TRANS/WP.29/820  
22 January 2002

World Forum for Harmonization of Vehicle Regulations (WP.29)

DRAFT SUPPLEMENT 6 TO THE 02 SERIES  
OF AMENDMENTS TO REGULATION No. 7

(Position, stop, and end-outline marker lamps)

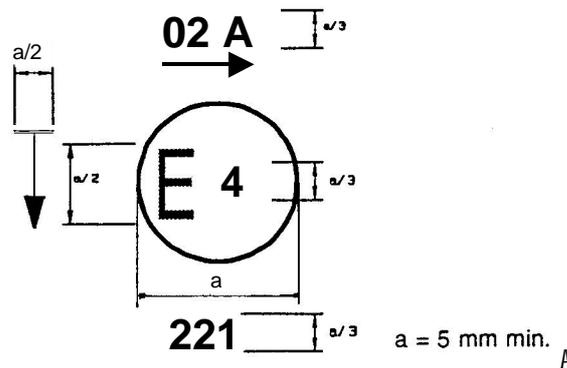
The example of the approval mark, amend to read:

A1. Front position (side) lamp

Caption below Figure 1, second sentence, amend to read:

A.... 02 series of amendments. The horizontal arrow indicates ....  
angle of 80° H. The vertical arrow starting from a horizontal  
segment and directed downwards indicates a permissible mounting  
height of equal to or less than 750 mm from the ground for this  
device.®
